RE: RESPONSE TO BARNSELY METROPOLITAN BOROUGH COUNCIL COMMENTS

Enzygo Ltd produced a Flood Risk Assessment (FRA) during November 2019 (Document Ref. CRM.1122.003.HY.R.001.A).

Barnsley Metropolitan Borough Council (BMCC) have reviewed the FRA and provided comments in relation to the planning application (Reference WA/2019/1117). A copy of the letter is included in Appendix 1.

TITLE:
Indicative Drainage Layout

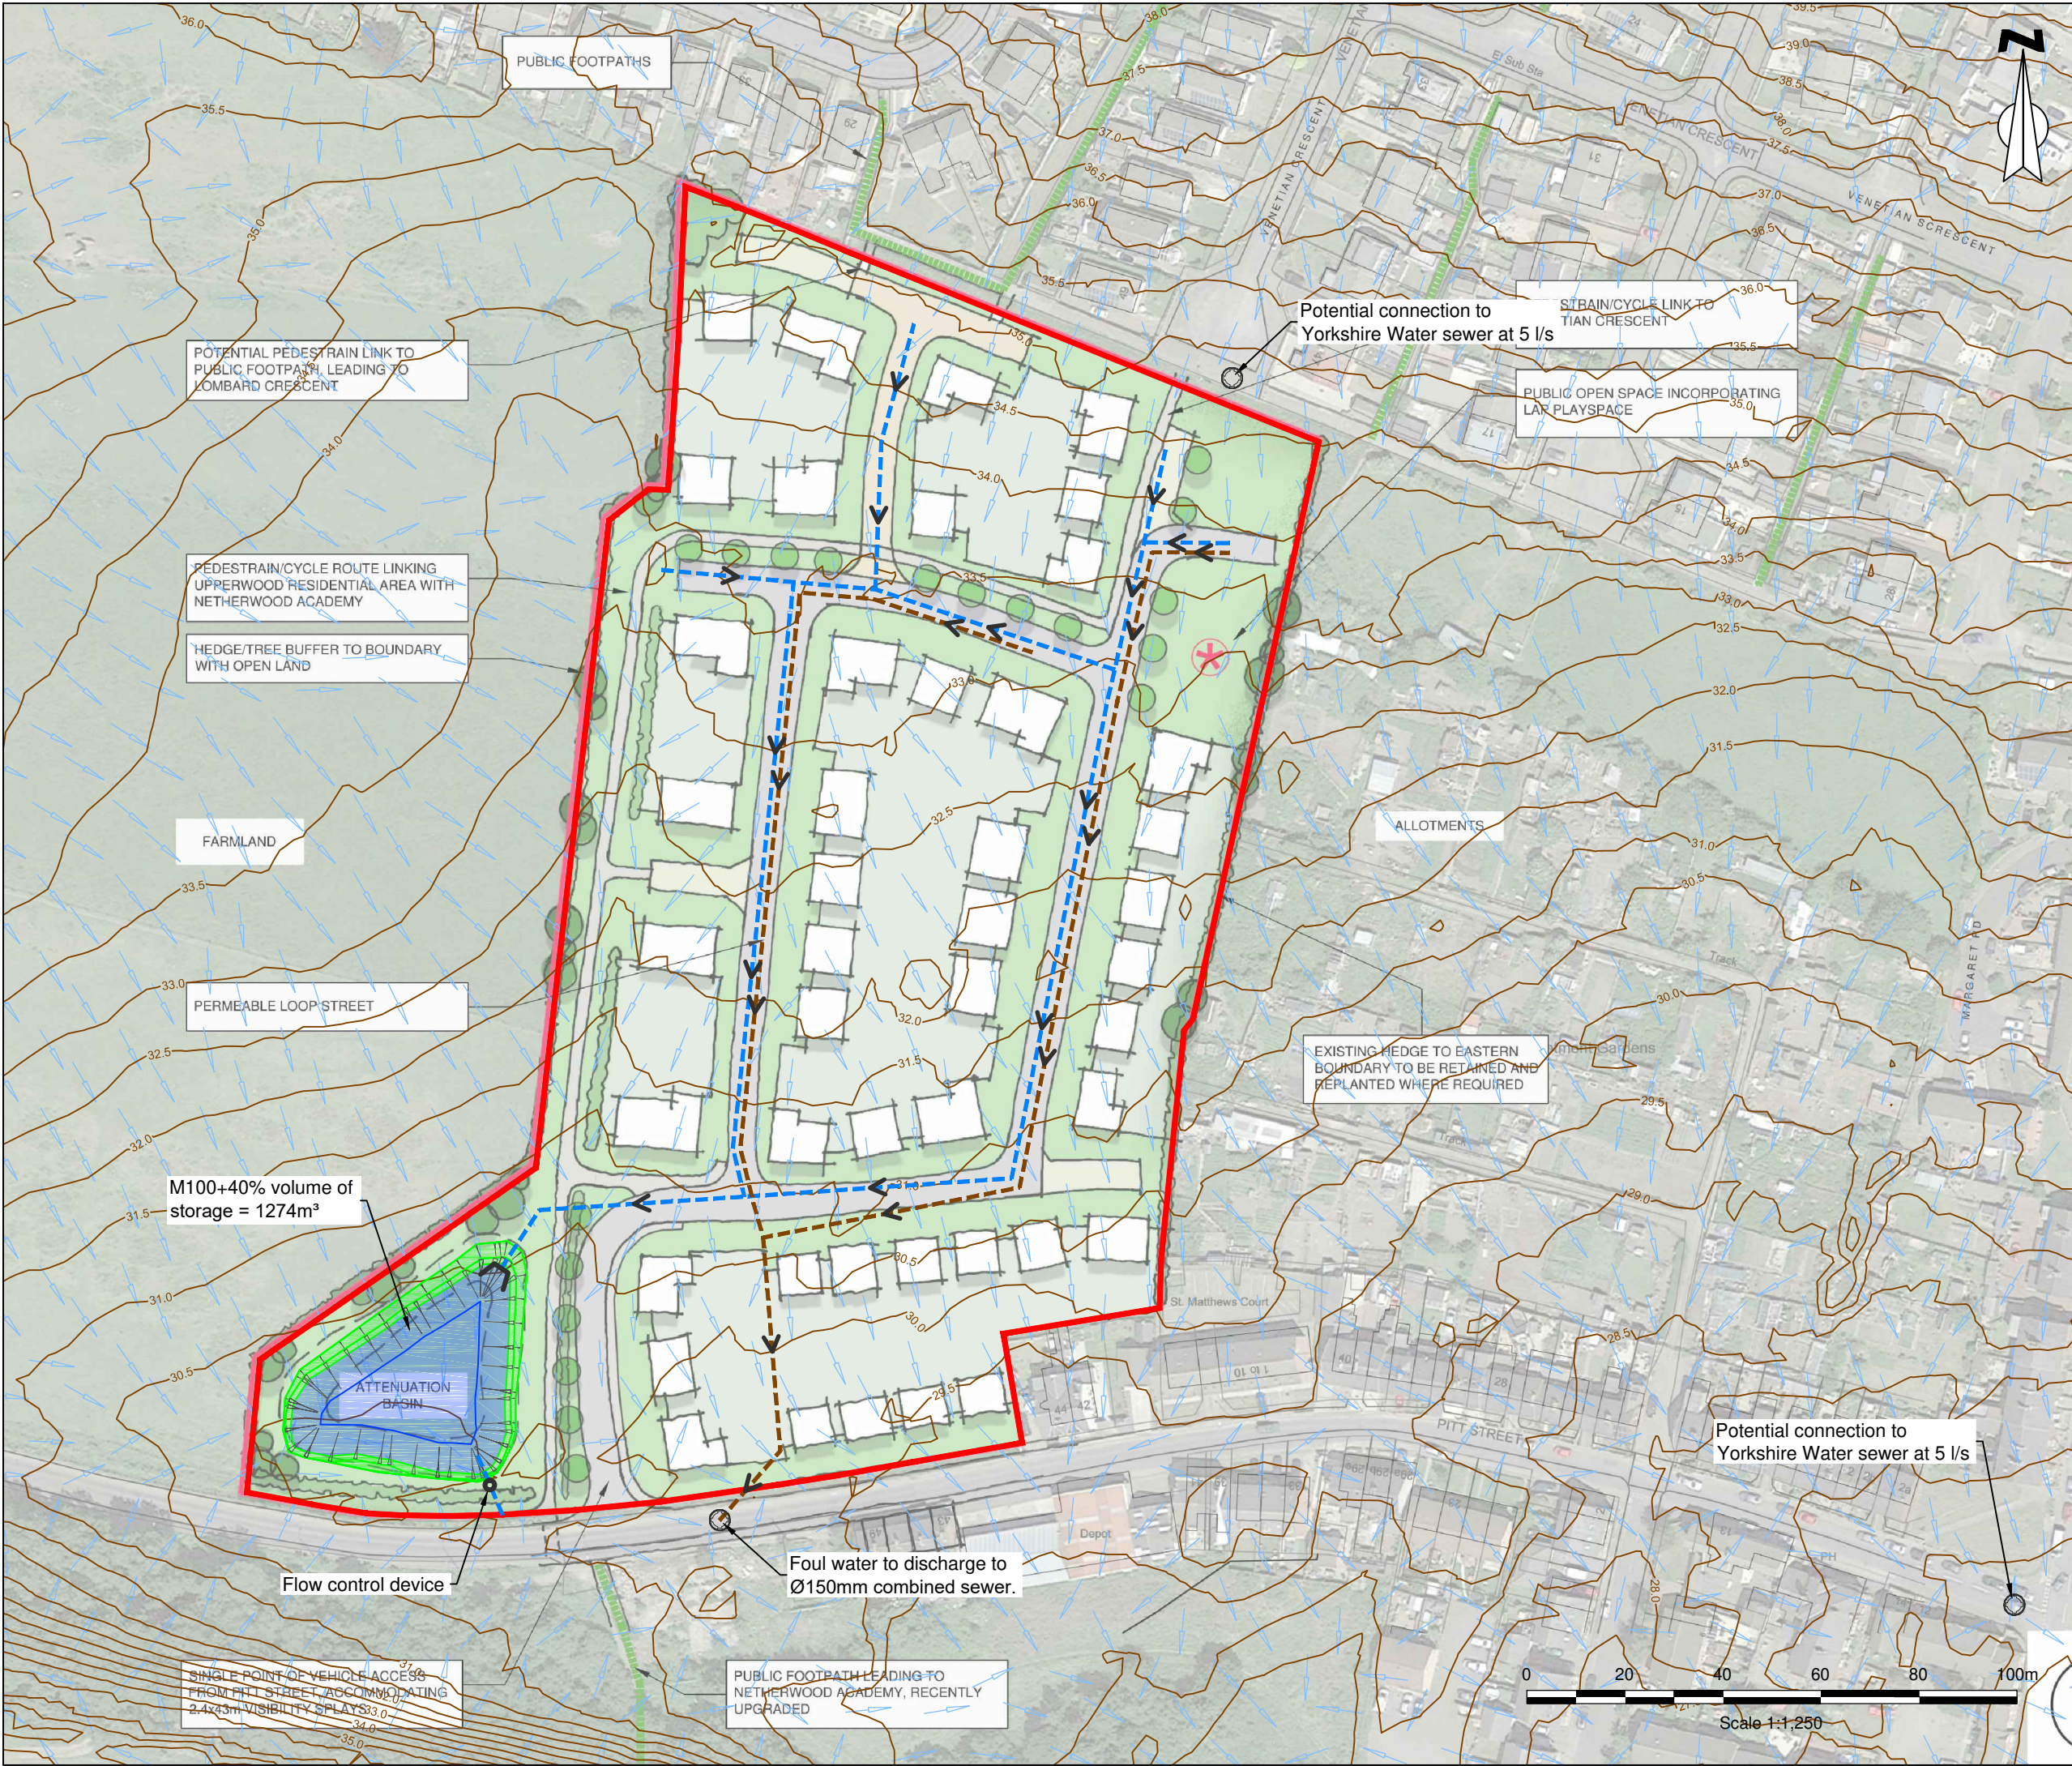
On the previous Pre-Application, I expressed concern regarding the drainage of this site. This application is unclear regarding the drainage of this site, with the application stating surface water to "main sewer", but the attached plans aren't clear on the final outfall. This site has caused flooding to the surrounding area in the past, so Surface water drainage details need to be determined at an early stage.

The foul and surface water systems would be discharged in separate systems. The foul water would discharge to the public combined sewer within Pitt Street. The surface water would discharge either to the surface water sewer within George Street to the east of the Site or to the surface water sewer located to the north of the Site. This has been agreed with Yorkshire Water at 5l/s subject to soakaway testing (Appendix 2). This is indicated on the indicative drainage drawing (Appendix 3).
